SUBJECT: REMEDIAL ACTION PLAN ADDENDUM
Oakland Truck Stop
8255 San Leandro Street
Oakland, California

This letter presents an addendum to ASE's August 17, 2007 remedial action plan (RAP). This addendum was requested in a letter from the Alameda County Health Care Services Agency (ACHCSA) dated September 11, 2007. Each technical comment is addressed below:

PROPOSED AREAS
 TO BE OVEREXCAVATED

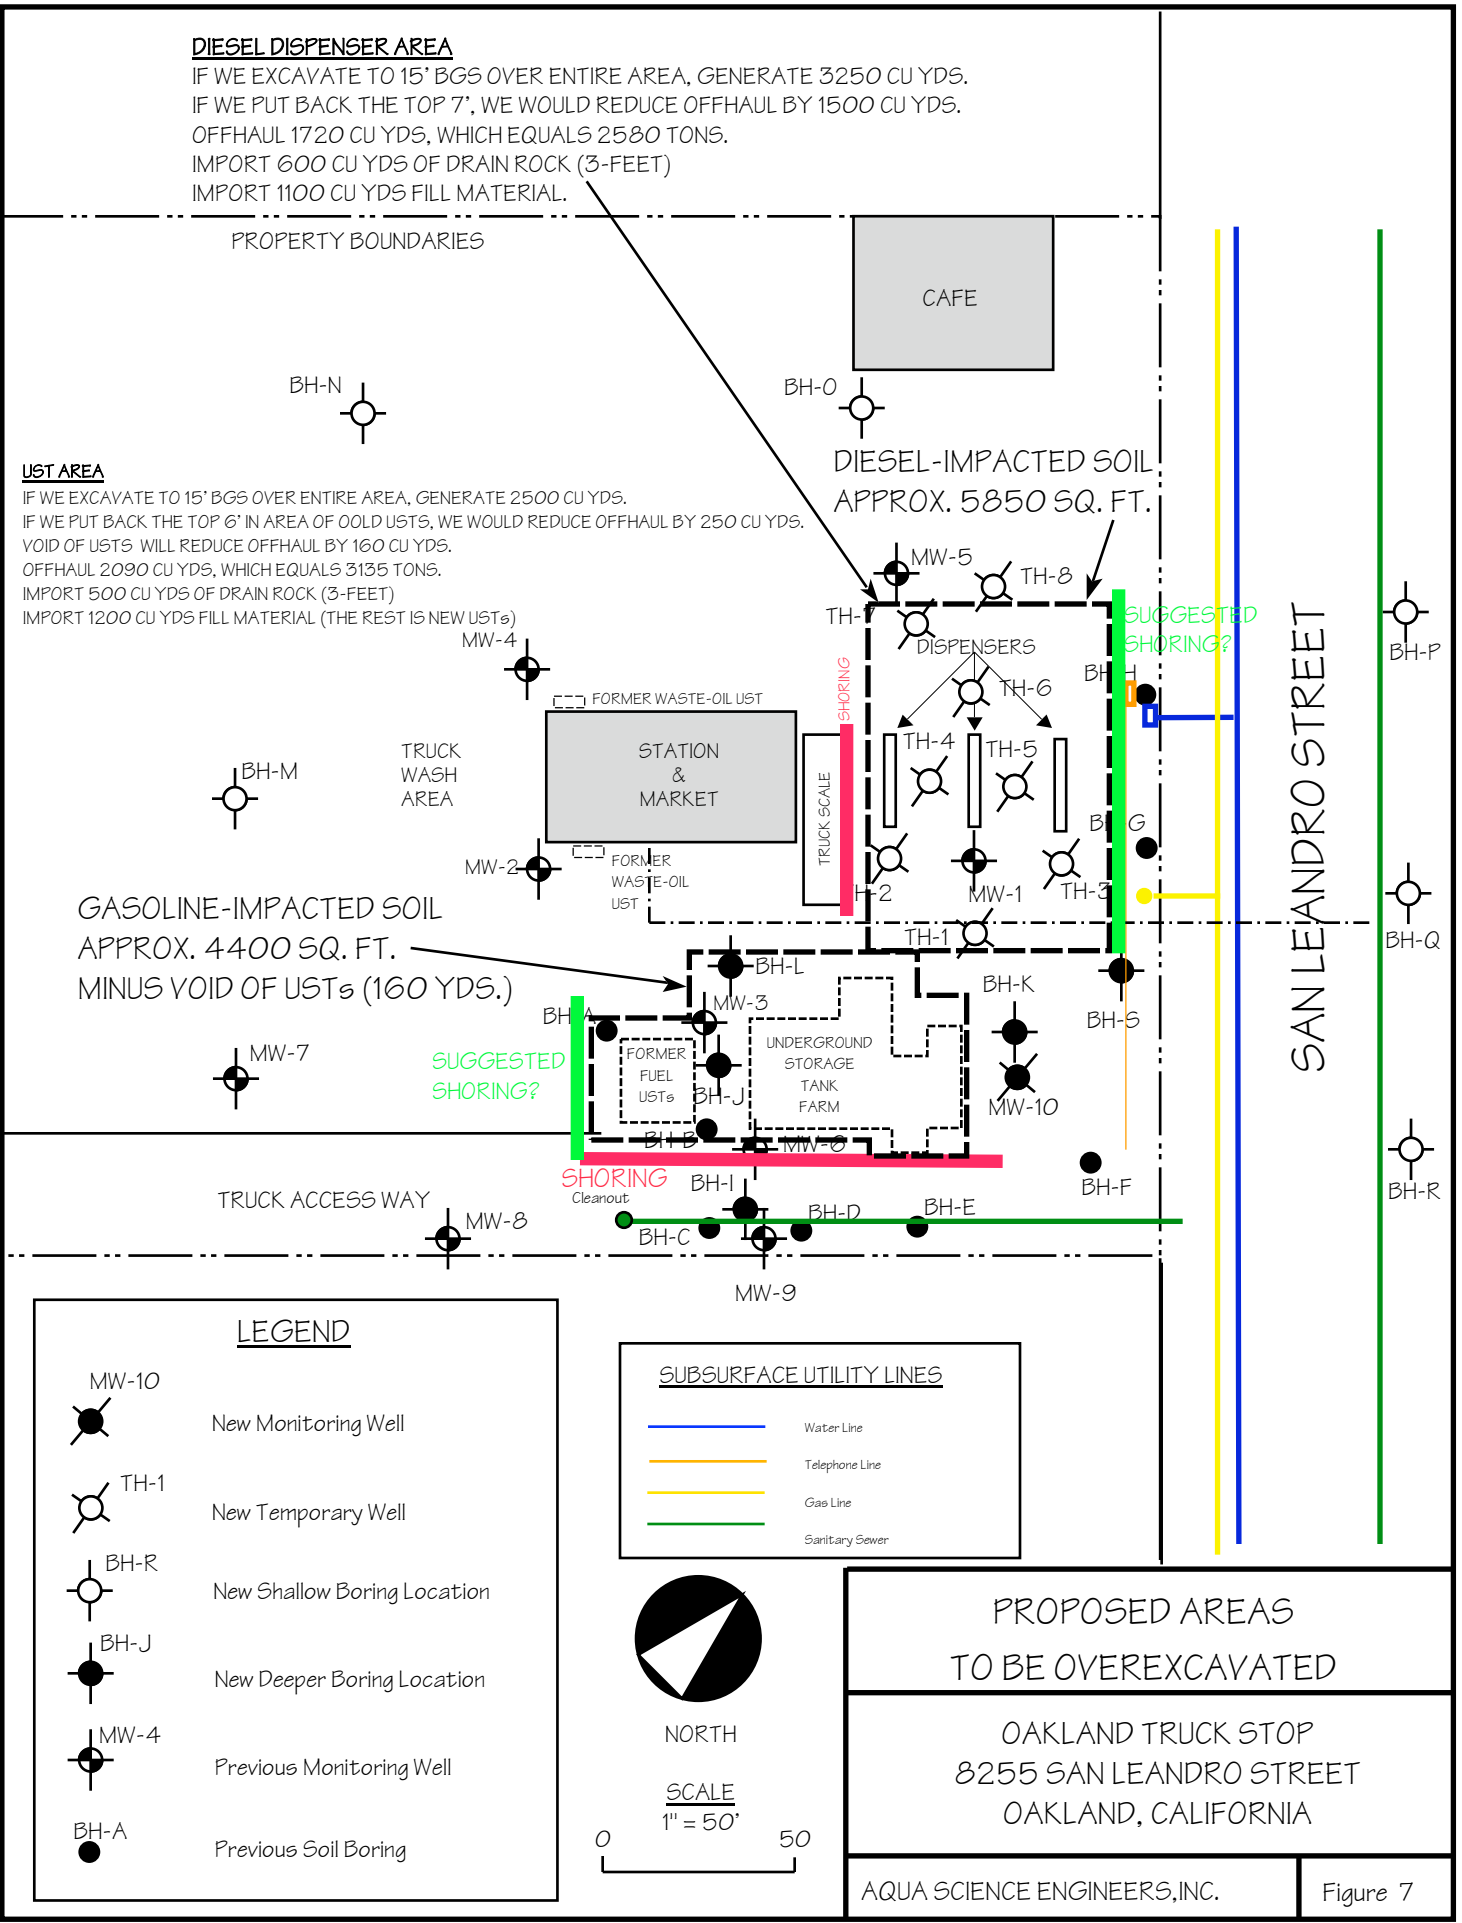
COMMENT 3 – PROPOSED AREAS FOR OVEREXCAVATION

The excavation areas have been modified slightly from the area shown in the RAP based on conditions observed in a recent site visit (see attached map). However, the excavation cannot be expanded to the south as requested in the September 11, 2007 letter for the following reasons:

- a) The portion to the south is an easement to the property west of the site (currently a truck driving school). This roadway easement is the only access to that property and it is not economically feasible to reroute traffic to that property since there is a bridge access. In addition, that property to the west will be used to stockpile clean overburden soil and will need to be accessed for this project.

- b) Although borings and monitoring wells to the south of our proposed excavation line do show groundwater contamination, no soil contamination has been identified in these borings/wells. It is ASE's experience that the UST Cleanup Fund will not pay for excavation in areas without soil contamination. If at the conclusion of the remediation, additional remediation is necessary in this area, it could be accomplished more economically in this area using an in-situ remediation such as the injection of Oxygen Releasing Compound (ORC) or an oxidizer such as Fenton's Reagent, RegenOx or other compound.
